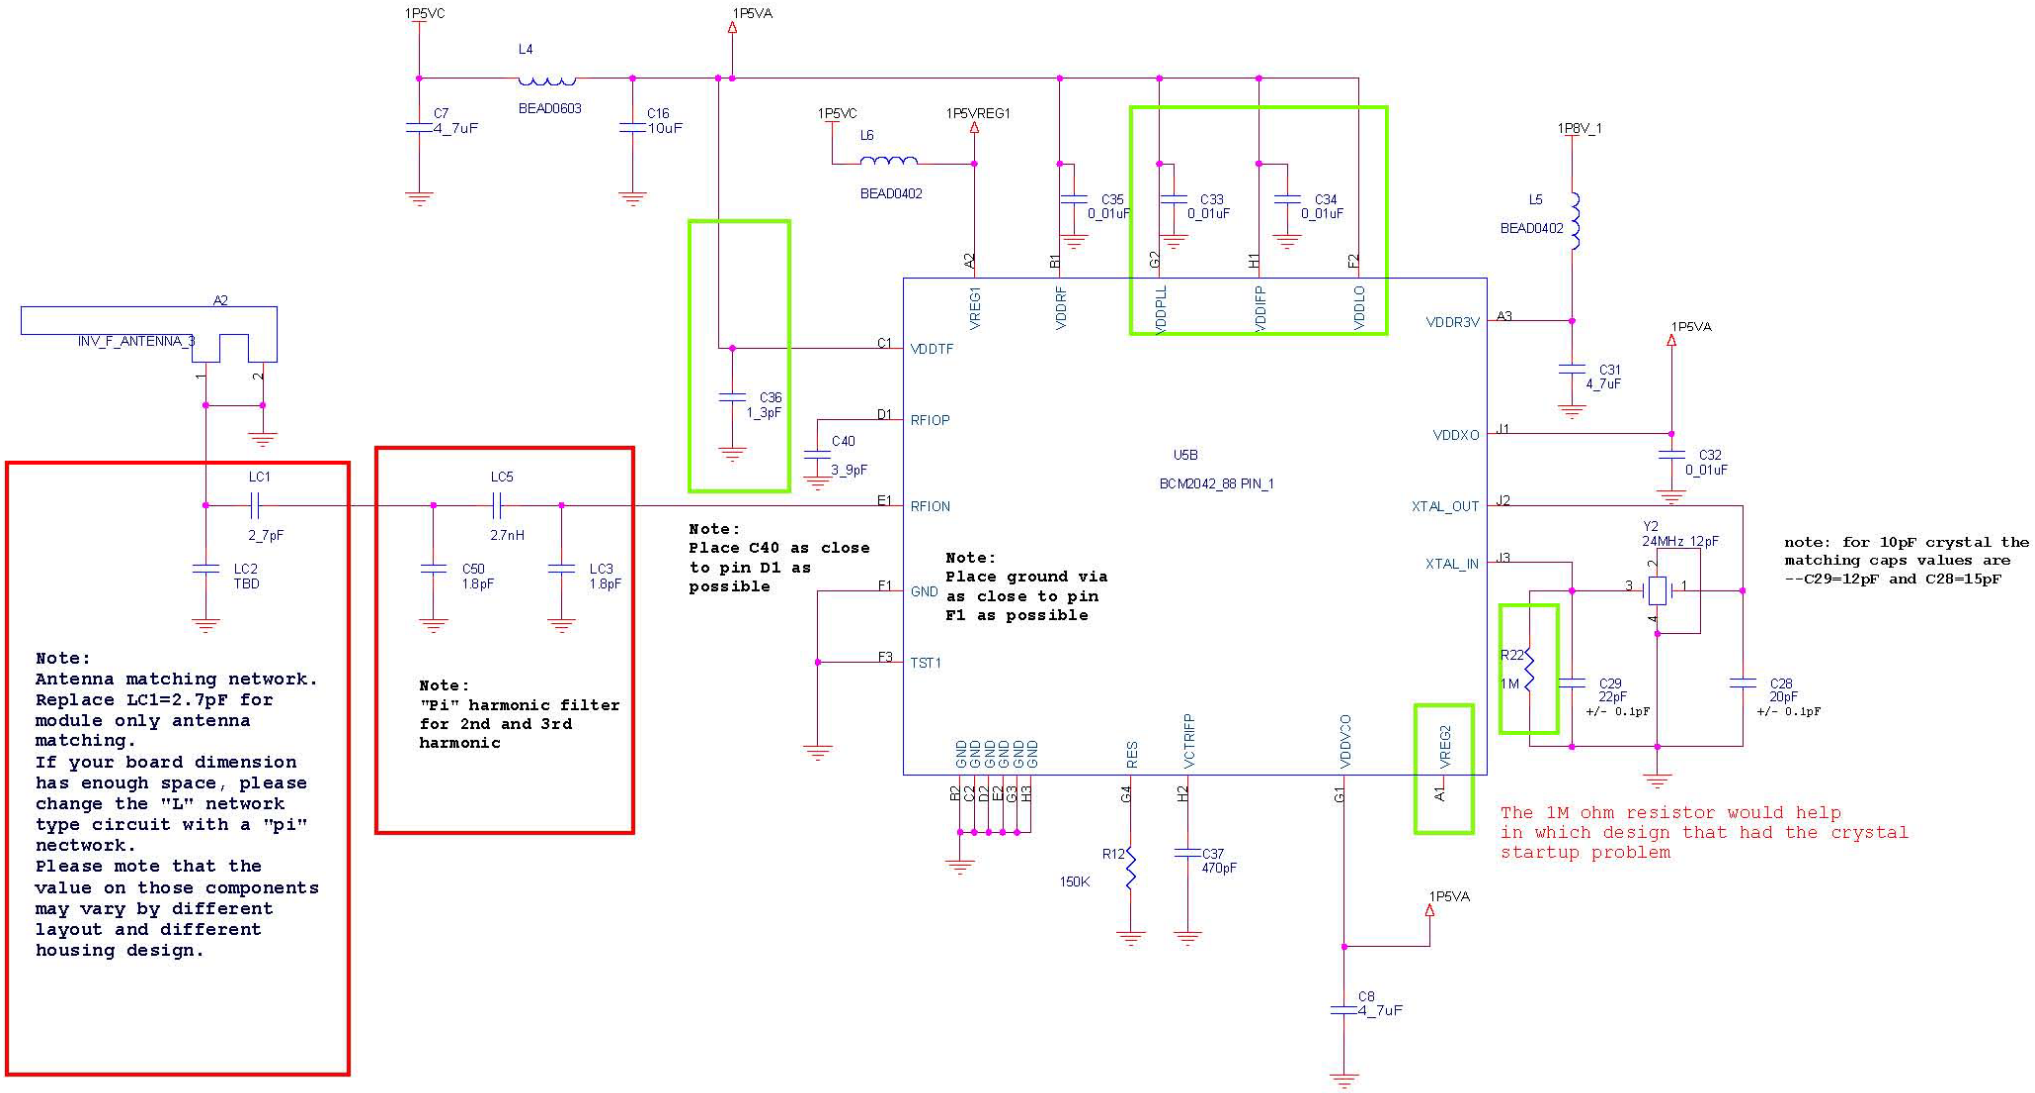
2.7nH
C50
1.8pF
LC3
1.8pF
VREG1
VDDRF
VDDPLL
VDDIFP
VDDLO
VDDTF
RFIOP
RFION
GND
TST1
U5B
BCM2042_88 PIN_1
VDDR3V
VDDXO
XTAL_OUT
XTAL_IN
C31
4_7uF
1P5VA
C32
0_01uF
Y2
24MHz 12pF
R22
1M
C29
22pF
+/- 0.1pF
C28
20pF
+/- 0.1pF
RES
VCTRIFP
VDDVCO
VREG2
R12
150K
C37
470pF
1P5VA
C8
4_7uF
Note:
Place C40 as close to pin D1 as possible
Note:
Place ground via as close to pin F1 as possible
note: for 10pF crystal the matching caps values are --C29=12pF and C28=15pF
Note:
Antenna matching network.
Replace LC1=2.7pF for module only antenna matching.
If your board dimension has enough space, please change the "L" network type circuit with a "pi" nectwork.
Please mote that the value on those components may vary by different layout and different housing design.
Note:
"Pi" harmonic filter for 2nd and 3rd harmonic
The 1M ohm resistor would help in which design that had the crystal startup problem
